UNITED STATES  
NUCLEAR REGULATORY COMMISSION  
WASHINGTON, D.C. 20555-0001

**KAIROS POWER LLC – FINAL SAFETY EVALUATION OF TOPICAL REPORT  
KP-TR-021-NP, “INSTRUMENT SETPOINT METHODOLOGY FOR THE KAIROS POWER  
FLUORIDE SALT-COOLED HIGH-TEMPERATURE REACTOR,” REVISION 1  
(CAC NO. 000431 / EPID L-2023-TOP-0033)**

**Figure 1 Setpoint Parameter Relationships (TR Figure 1)**

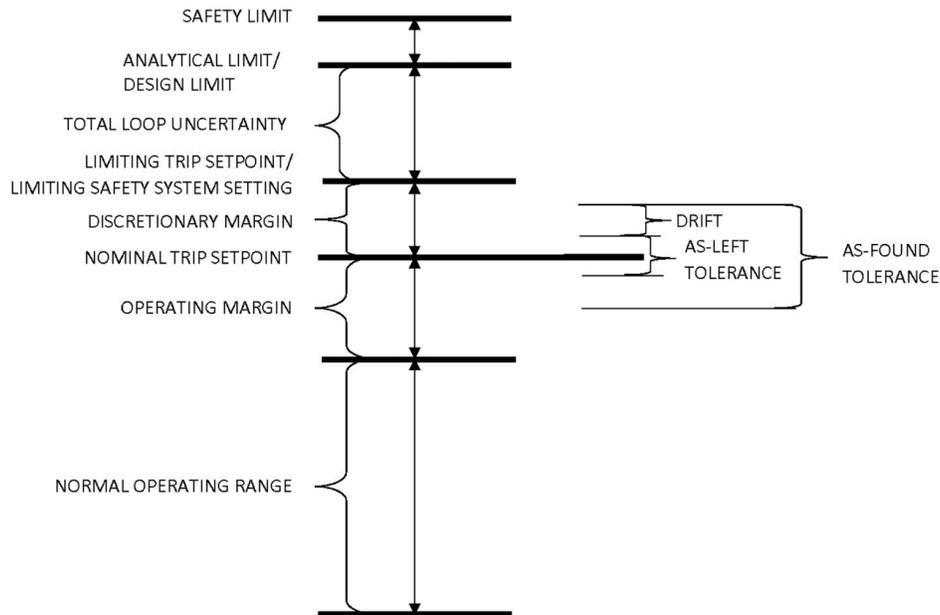
The NRC staff reviewed TR Figure 1, “Setpoint Parameter Relationships,” shown below in Figure 1, and compared it to Figure 1, “Relation Between Setpoint Parameters,” of ANSI/ISA-67.04.01-2018 (ANSI Figure 1) which depict relationships between various setpoints, margins, limits and other setpoint parameters. RG 1.105, Revision 4, states that “Figure 1 of ANSI/ISA 67.04.01-2008 [(ANSI Figure 1)] illustrates setpoint relationships for nuclear safety-related setpoints.” The NRC staff determined that the TR Figure 1 is comparable to ANSI Figure 1 in that the types of setpoints parameters (e.g. setpoints, margin, limits, etc.) and relative relationships are represented similarly. For these reasons, the NRC staff finds that the Kairos setpoint methodology conforms to RG 1.105, Revision 4, with respect to relationships between setpoint parameters for safety-related instrumentation.

The NRC staff reviewed TR Section 3, "Establishment of Setpoints," Figure 1, "Setpoint Parameter Relationships," Figure 2, "Setpoint Calculation Flowchart," and Equations 12 through 15. In the Kairos methodology, the AL is provided by the plant's safety analysis, to ensure that a trip occurs before the SL is reached. The purpose of an LTSP is to ensure that a protective action is initiated before the process conditions reach the AL. NTSPs are calculated using the LTSP and discretionary margin as shown in TR Equations 12 through 15. Discretionary margin applied must be greater than or equal to the AFT to ensure the LSSS specified in the plant TS is not exceeded. The NTSP is evaluated with respect to normal operational limits and margin, if any, and is established to protect against inadvertent trip actuations, which is consistent with ANSI/ISA-67.04.01-2018. For this reason, the NRC staff finds that the Kairos setpoint methodology conforms to RG 1.105, Revision 4, with respect to calculating and selection of a trip setpoint.

**Figure 2**      **Scaling or Conversion Process**

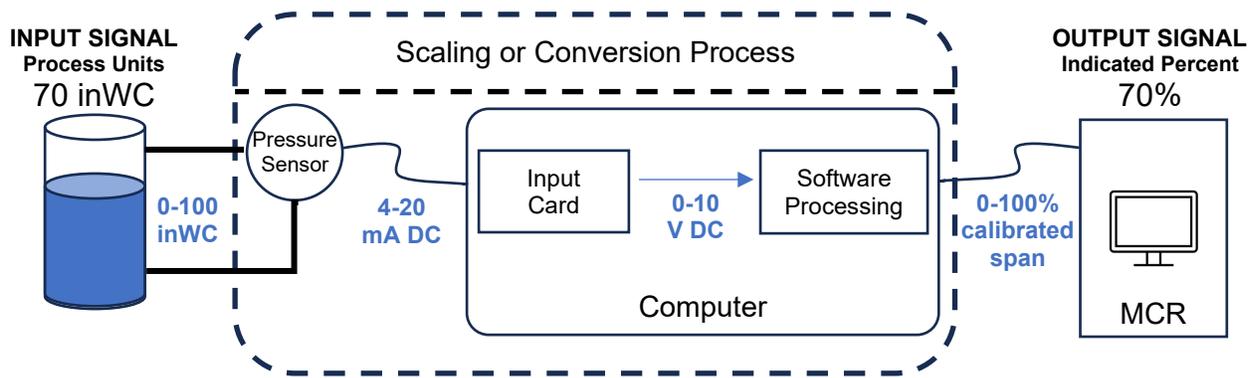
The NRC staff reviewed TR Section 2.4 and noted that although it states that "[i]ndividual uncertainty terms are calculated in terms of percent calibrated span..." it does not describe the relationship between instrument and process measurement units. However, the methodology references ISA-RP67.04.02-2010, which describes this relationship by stating that trip setpoint values usually require transformation from process parameters to voltage or current values. For example, an analog pressure transmitter loop may contain an electronic comparator whose trip setting is measured and set in milliamperes of current. This conversion or scaling process can typically be described as a simple linear equation that relates process variable units to measurement signal units. This scaling process would also apply to ALT and AFT. Although ISA-RP67.04.02-2010 is not endorsed by the NRC, based on its review, the NRC staff determined that the methodology referenced in ISA-RP67.04.02-2010 provides applicable guidance for the implementation of ANSI/ISA-67.04.01-2018.

Using the methodology described in ISA-RP67.04.02-2010, a setpoint provided in percent span is calibrated at the sensor in process units [e.g., sensor input is 0-100 inches of water column (inWC), output is 4-20 milliamp direct current (mA DC), the computer input card input is 4-20 mA DC, output is 0-10 volts (V) DC]. The software converts 0-10 V DC to 0-100 percent span. Thus, a 70 percent span setpoint indication at main control room equates to 70 inWC at the process and is represented below in Figure 2. Additional discussion on the scaling or conversion process is described in ISA-RP67.04.02-2010, Section 9. Based on the above, the NRC staff finds that the Kairos setpoint methodology is consistent with ISA-RP67.04-0210, and therefore conforms to RG 1.105, Revision 4, with respect to converting percent calibrated span into process measurement units within a trip setpoint calculation.
